Zion Nuclear Power Station, Units 1 and 2
Facility Operating License Nos. DPR-39 and DPR-48
NRC Docket Nos. 50-295 and 50-304

Subject: Submittal of Defueled Safety Analysis Report Update, Revision 3
Report of Changes, Tests and Experiments

**ZION NUCLEAR POWER STATION
DEFUELED SAFETY ANALYSIS REPORT REVISION 3**

Figure 4-1

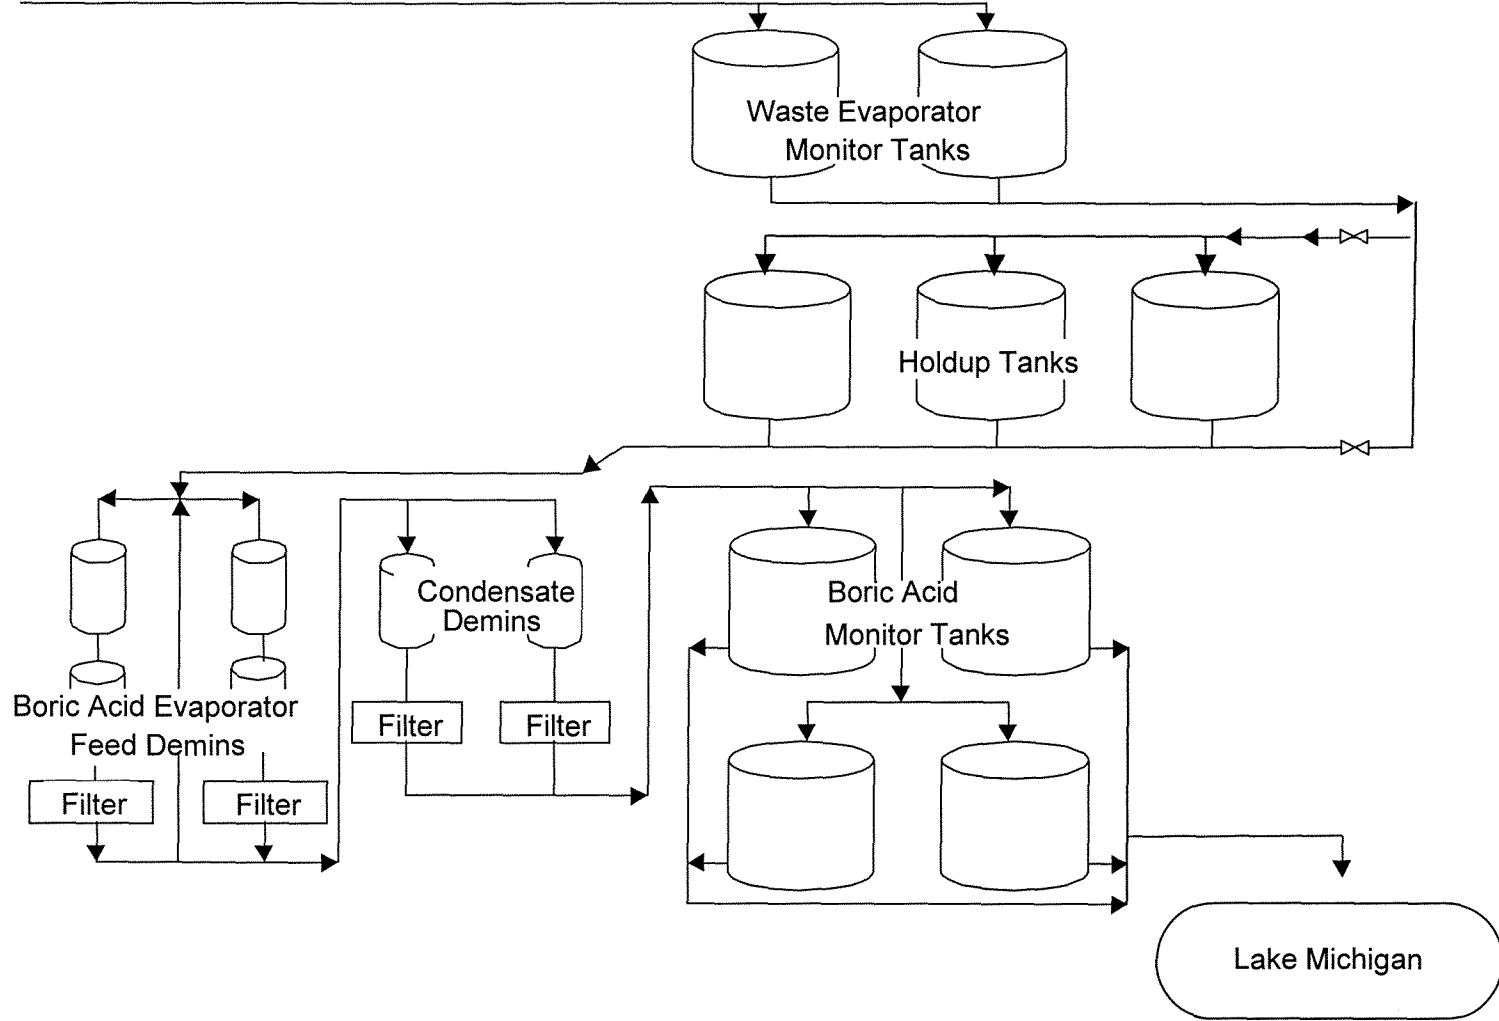
Pages	Description of Change
LOEP-1, 4-ii, 4-6, 4-7, 4-14, Table 4-1, Table 4-3, Figure 4-1	Delete List of Effective Pages (LOEP) page 1. This administrative information is obsolete. Delete references to the Lake Discharge Tanks (LDTs) and insert references to the Boric Acid Monitoring Tanks (BAMTs). The LDTs have been abandoned. The liquid effluent system has been modified to use the BAMTs as the liquid effluent release tanks.
4-16, Table 4-2	Delete description for Fuel Building area radiation monitors ORE-0005 and ORT-AR03. Insert discussion for Fuel Building area radiation monitors ORT-AR21 and ORT-AR22. The area radiation monitor system has been modified to replace area radiation monitors ORE-0005 and ORT-AR03 with ORT-AR22 and ORT-AR21 respectively.
3-v, 3-53, 3-54	Revise description of control room design. Add discussion of plant pager alarm system.
